# UNITED STATES PATENT AND TRADEMARK OFFICE

10/572,865

<b>Office Action Summary</b>	<b>Application No.</b> 10/572,865	<b>Applicant(s)</b> MOORE ET AL.	
	<b>Examiner</b> Larry E. Waggle, Jr	<b>Art Unit</b> 3775

## **DETAILED ACTION**

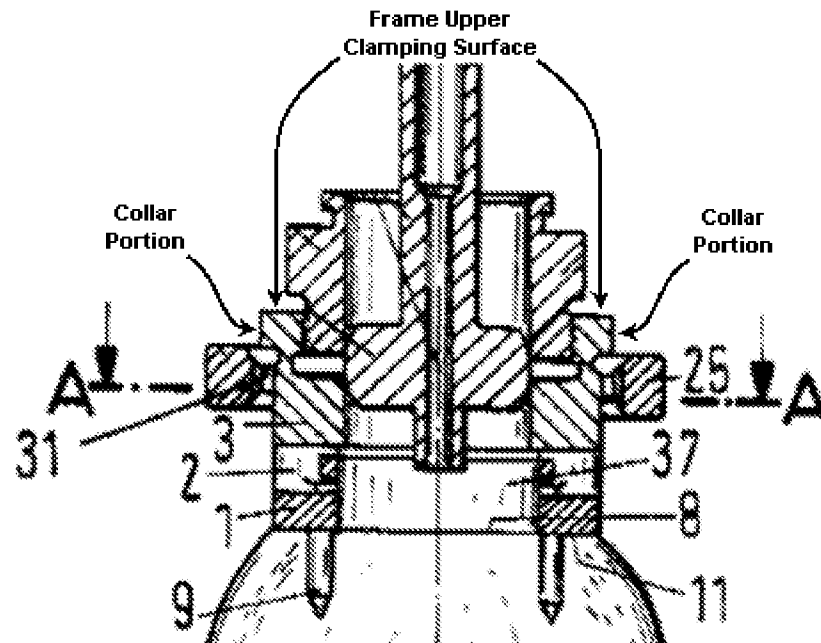
**Claims 1-3 and 8-13** are rejected under 35 U.S.C. 102(b) as being anticipated by Marchione et al. (US Patent 6595999).

Marchione et al. disclose a drill guide assembly comprising a drill guide (6) that includes a sleeve and a bulb (7) at one end of the sleeve (Figure 5), a frame fastenable (via 9) to a bone that includes a housing (3) which defines a recess (32) in which the drill guide bulb can be received with the drill guide sleeve extending out of the recess in a direction away from the bone, so that the angular orientation ( $\alpha$ , Figure 5) of the drill guide sleeve relative to the housing can be adjusted by movement of the bulb within the recess (column 2, lines 37-41), a clamp (5) comprising a lower pair of clamping surfaces provided by the drill guide bulb and the internal wall of the recess (5, 7 and 32 in Figure 10) respectively facing generally towards the patient's bone, an upper pair of clamping

surfaces on the drill guide and on a hollow collar portion of the housing respectively facing generally away from the patient's bone and being spaced apart from the bulb along the drill guide sleeve (see annotated Figure below), arranged so that the drill guide can be locked against angular adjustment by engagement between the frame clamping surfaces and the drill guide clamping surfaces of each of the lower and upper pairs; an actuator (29); and an alignment stylus (13) connected to the drill guide to move with the drill guide relative to the frame including a first limb that is directed towards the bone, to facilitate assessment of the alignment of the drill guide sleeve relative to anatomical features of the bone, wherein the stylus can be moved rotatably around the drill guide sleeve, the stylus can be moved around the drill guide sleeve while the clamp is engaged to prevent angular movement of the drill guide relative to the frame, and wherein the stylus includes a second limb extending from the first limb in a direction generally towards the axis of the assembly (Figure 8 and column 5, lines 25-60), and the frame provides a platform (top of 2, displacement element in Figure 9) that defines a plane that is spaced apart from the bone and an axis of the assembly (along 14) that extends perpendicular (column 5, lines 13-19) to the said plane, and wherein the drill guide is mounted on the platform so that it can be translated relative to the frame generally in the plane of the platform which includes a lock (25), and wherein the clamp and the lock can be engaged and disengaged independently of one another (column 4, lines 11-57).
